VILLAGE OF DOWNERS GROVE  
COUNCIL ACTION SUMMARY

**A RESOLUTION APPROVING THE FINAL PLAT  
OF SUBDIVISION FOR THE GOLFVIEW ESTATES SUBDIVISION WITH EXCEPTIONS**

Golf View Estates Subdivision, PC-15-04  
 Planning & Community Development

**TO:** Amanda G. Riordan, Planner - Planning & Community Development  
**FROM:** David H. Barber, P.E., Director of Public Works *DHB*  
**BY:** Michael D. Millette, P.E., Asst. Director of Public Works – Engineering *MDM*  
Jonathan C. Hall, P.E., Development Engineering Manager *JCH*  
**DATE:** April 14, 2005  
**RE:** Proposed Revisions to Golf View Estates Subdivision  
Revised Documents – **4<sup>th</sup> Review (Final Submittal)**

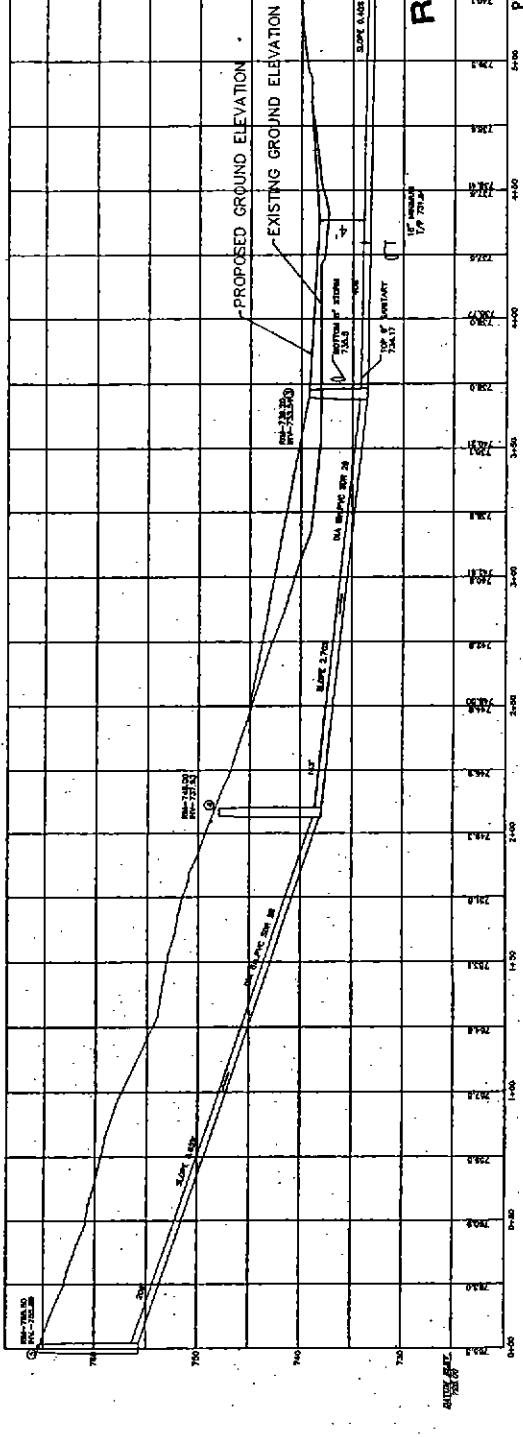
- 14. Replace Inlet 2 with a catchbasin (48-inch diameter, 36-inch sump).
- 15. Change the title of Sheet 5 to reflect storm sewer and water systems in addition to the sanitary sewer. Label the 8-inch PVC pipe as "storm sewer."
- 16. Route sump pump discharges to the rear yards. An effort should be made to maintain the pipe alignments within approximately 5 to 10 feet of the side property lines so as not to interfere with use of the rear yards. The discharge point must be at least 5 feet from any property line. To prevent impact on neighbors, we recommend that the sump pumps discharge within 30 feet of the rear property line.

4. Underground Improvements note 3.d.1 should specify CA-7 backfill for the sanitary sewer.
5. Show all existing and proposed lot numbers on the plans.
6. Elevations should be added to the scale in the profile view (Sheet 6), and the horizontal scale should be corrected (Sheet 5).

GRADING AND  
SOIL EROSION  
PLAN

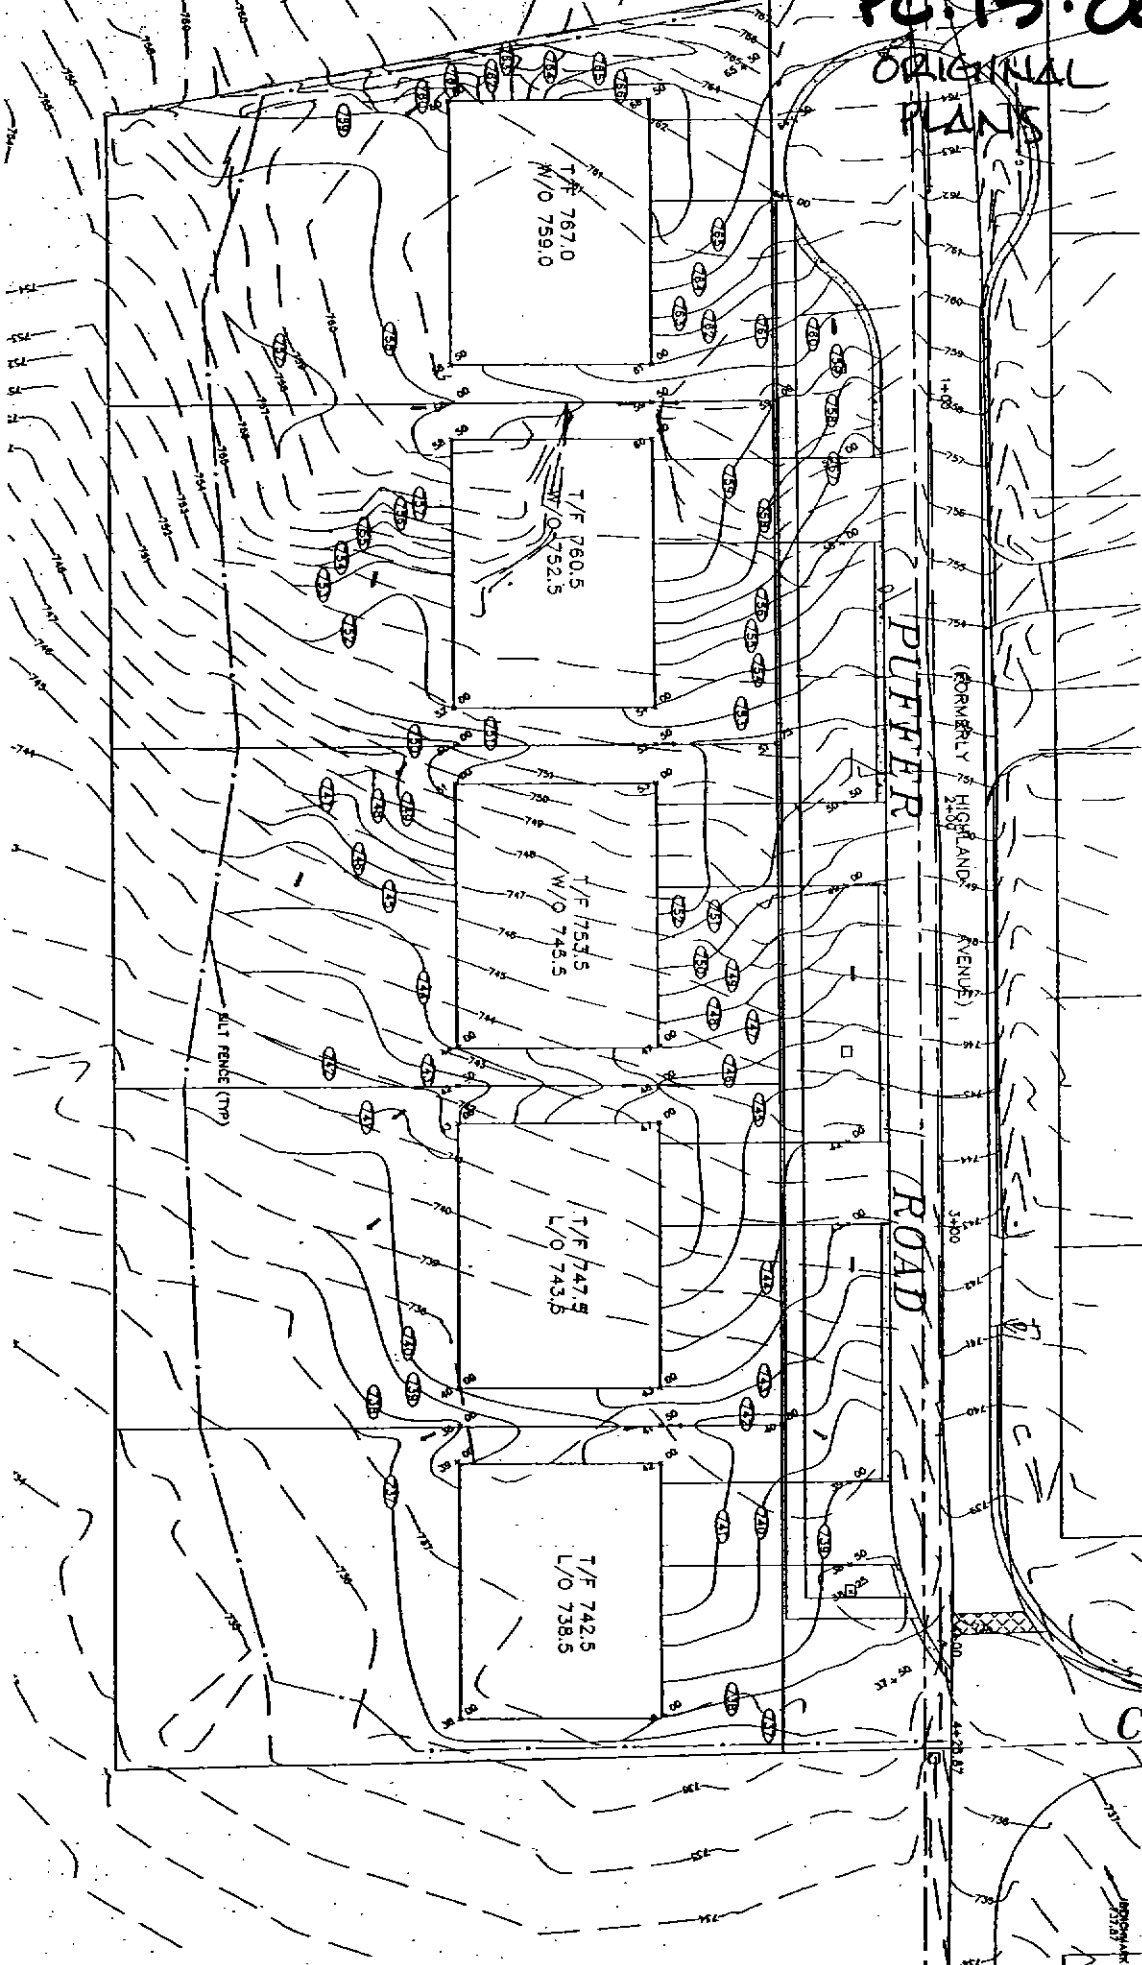
2. Within 5 feet of all structures, the slope must be clearly defined away from the structure (2% to 5% recommended). This can be adjusted with the individual lot grading plans.

3. Driveway slopes should not exceed 10% within the right-of-way. This limit is also recommended for the remainder of the driveway.  
**Accepted – The grading plan complies to the extent possible under existing constraints**

4. Sidewalk longitudinal slopes should not exceed 15% and cross-slopes, should be limited to 2%.  
**Accepted – The grading plan complies to the extent possible under existing constraints**

***Accepted – To be addressed with individual house permit grading plans***

### Cul-de-sac Configuration

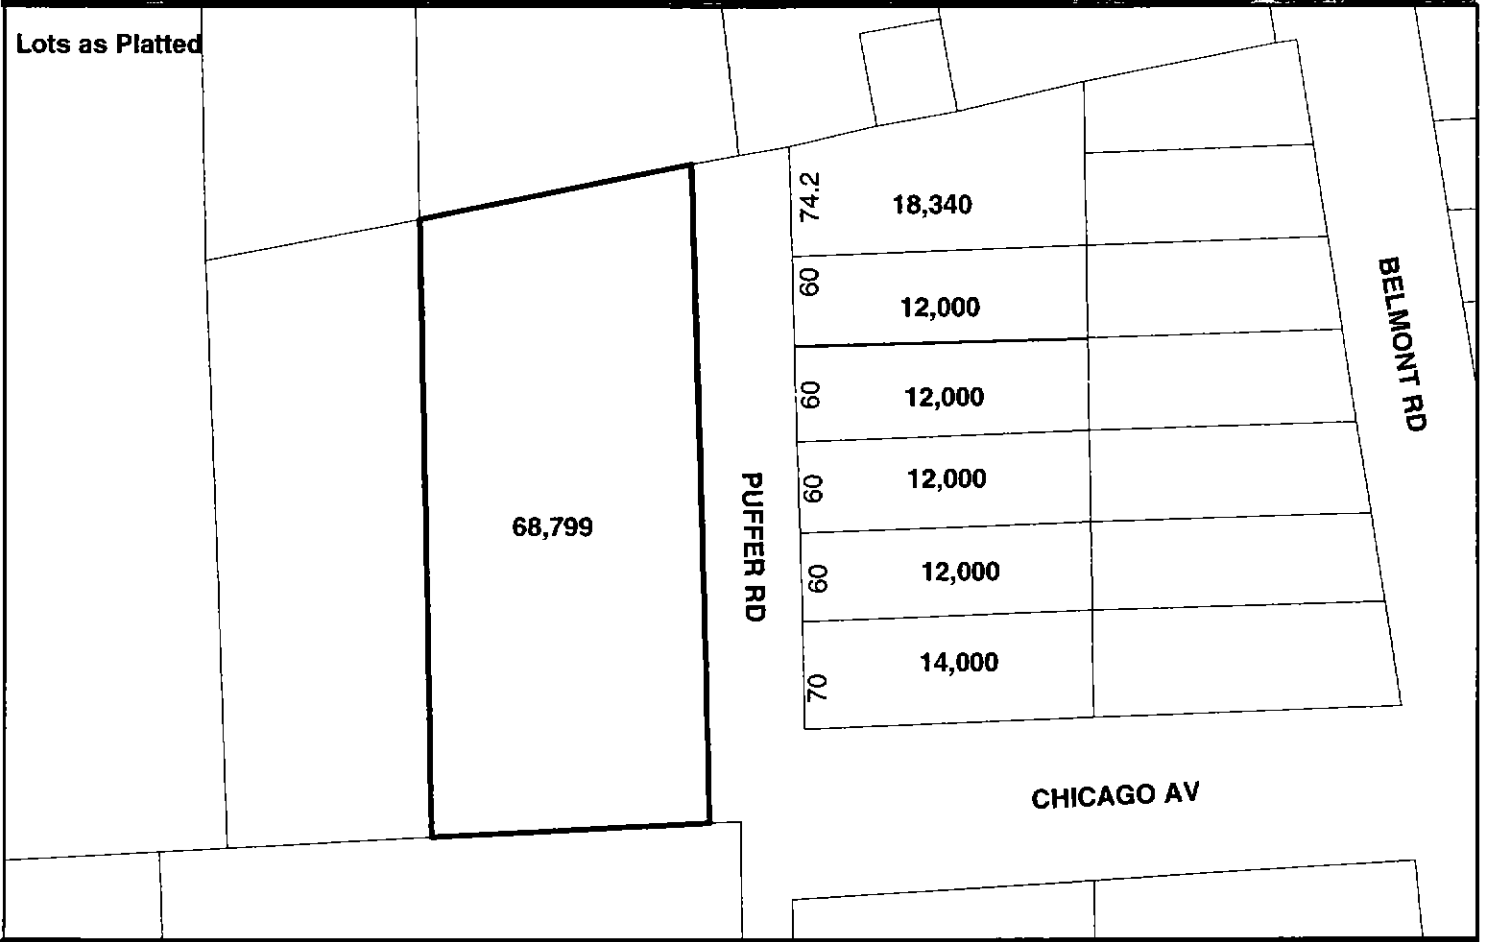
The question also arose concerning the original configuration of the cul-de-sac and whether it would have "taken" property from the Barr property. Commissioner McConnell is correct that as the cul-de-sac, both as it was originally proposed and as it has been revised, is completely located within the public right-of-way. The revised configuration, however, results in less of a reduction of "parkway" adjacent to the Barr property (ie: greenspace within the public right-of-way) than as it was originally proposed. This was accomplished by the petitioner by reducing the lot area of proposed Lot 1 and dedicating additional right-of-way to accommodate the bulb of the cul-de-sac facing the subject property (see revised Plat of Subdivision).
